**Loop 303 Corridor/White Tanks
Area Drainage Master Plan Update
Contract FCD 99-40**

**Level I Alternatives
Analysis Report**

Flood Control District of Maricopa County

Comment Responses for Level I Report: General Comments

FIGURE 3.1
URS

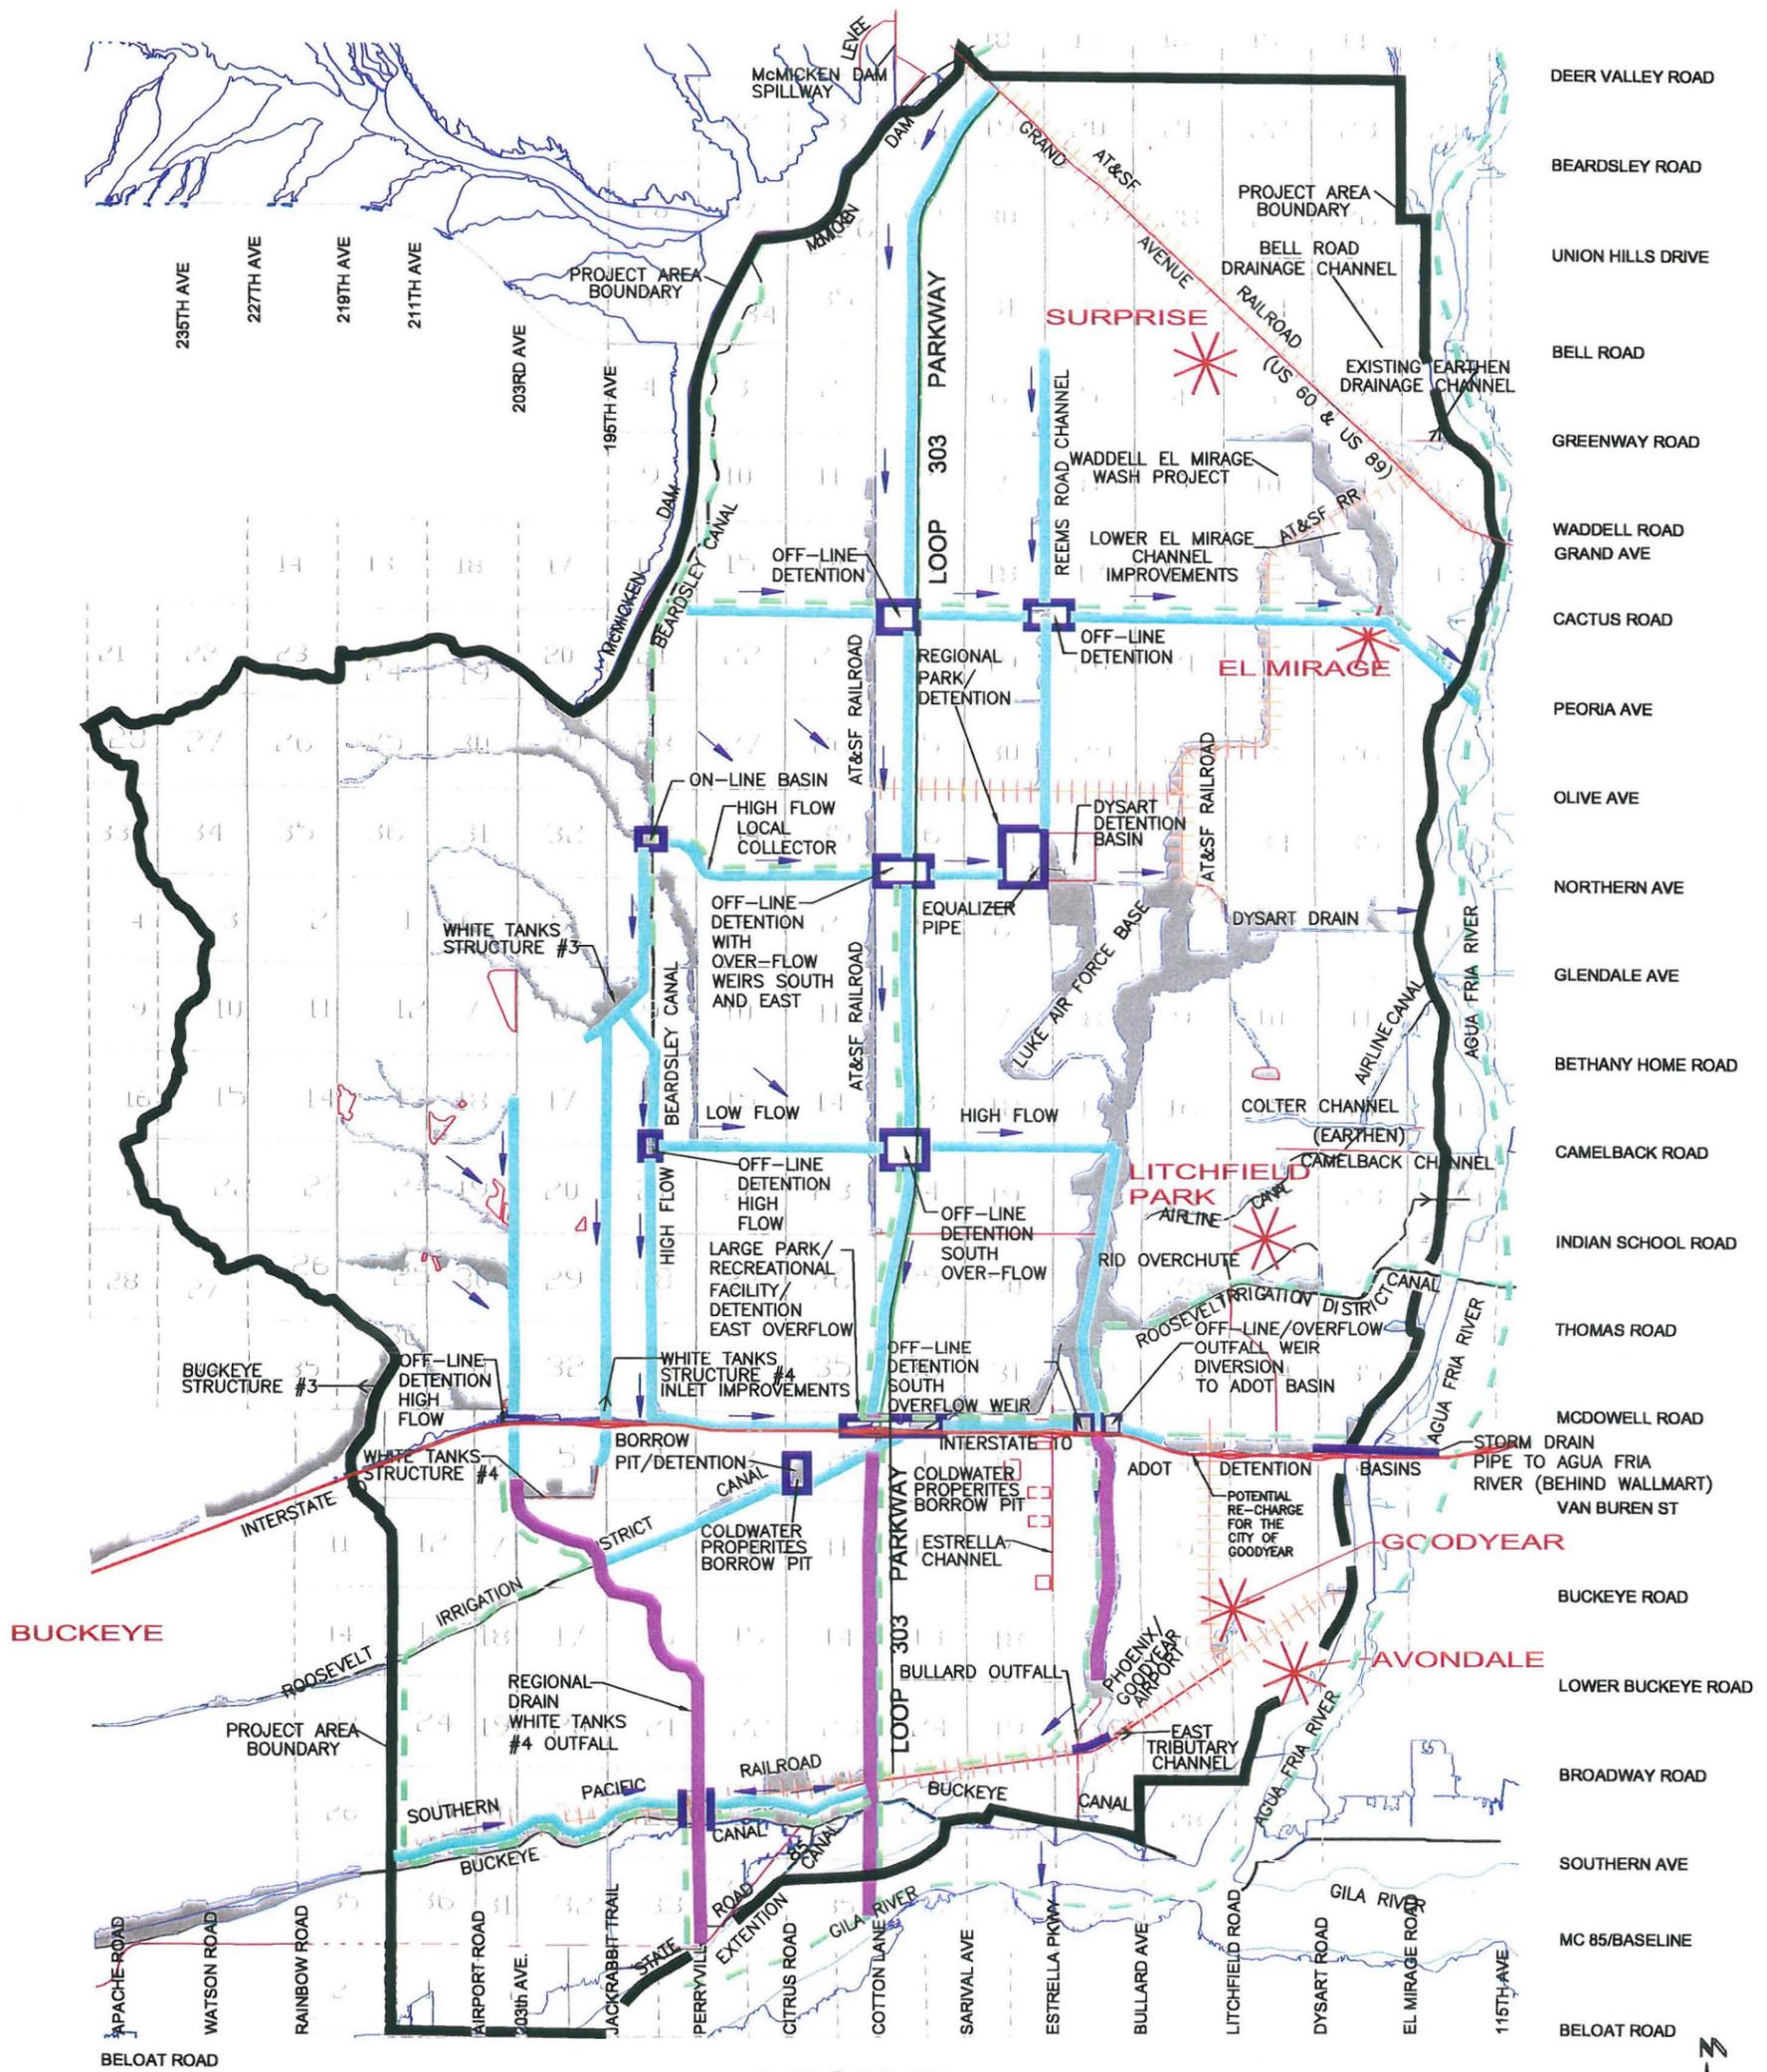
16. **Figure 3.1 – Place either at start or end of each alternative description. This will break up the text and make it clear as to what you are presenting. Typical for all figures.** *Figures will now be inserted the page before the alternative description.*

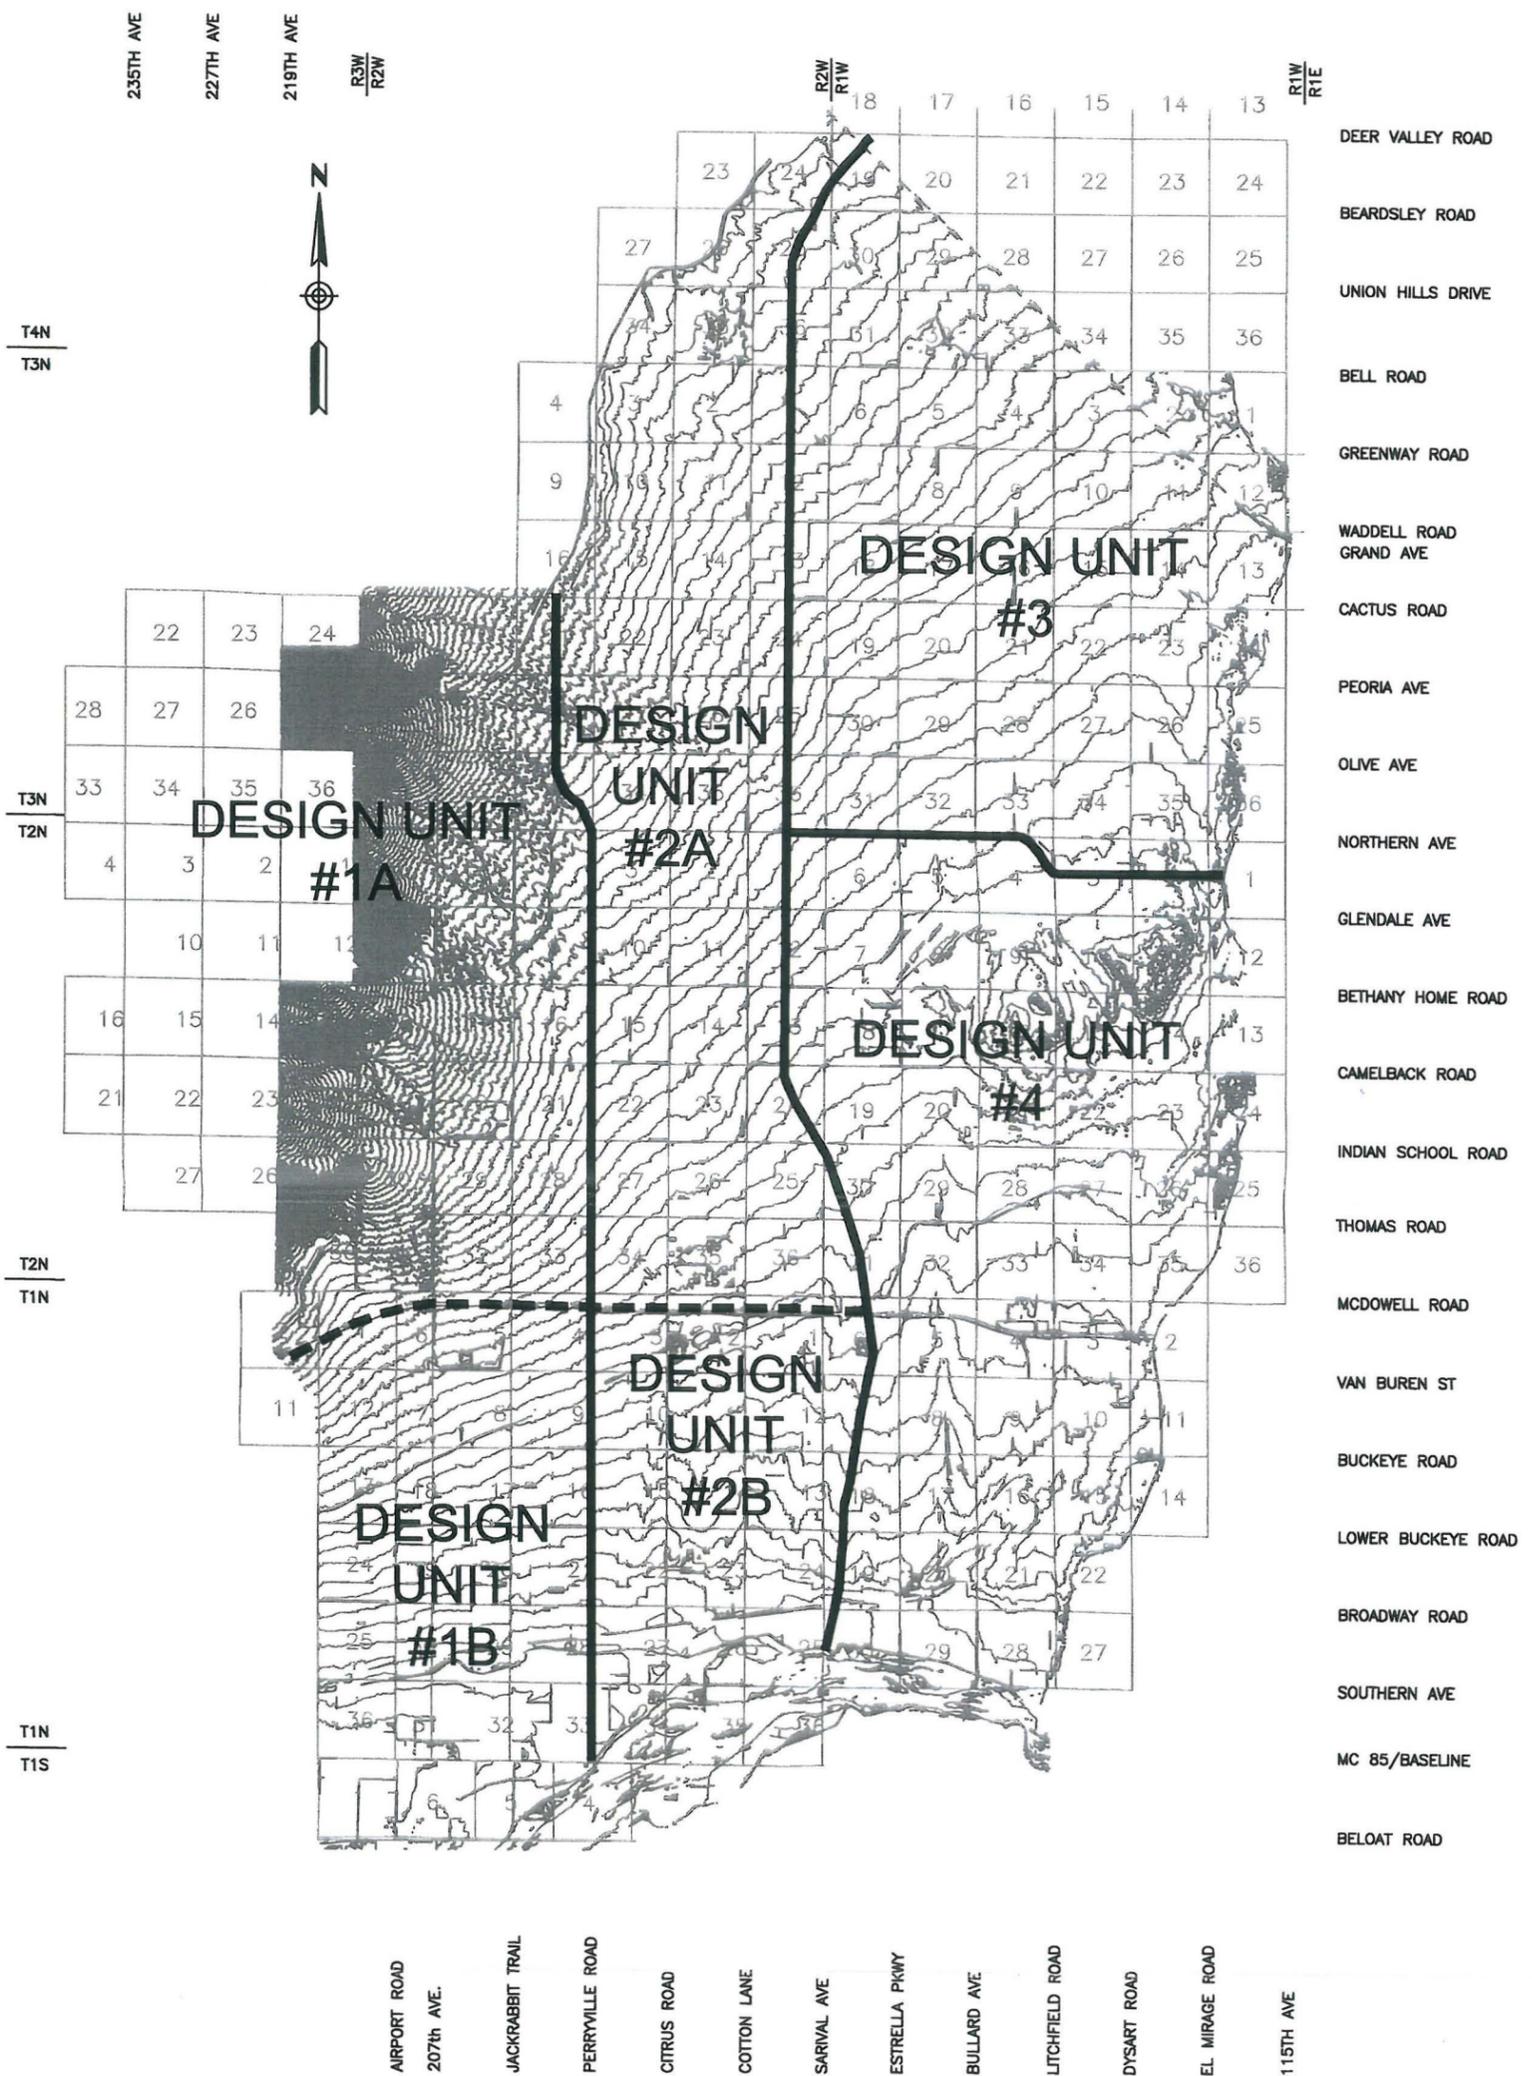
19. **Figure 3.11 – Add date.** *Date added to Figure along with updated title block.*
20. **Page 4-1 – Make reference to Sections 5 and 6 or insert as indicated in the following documents.** *References have been made to these Sections in the text.*
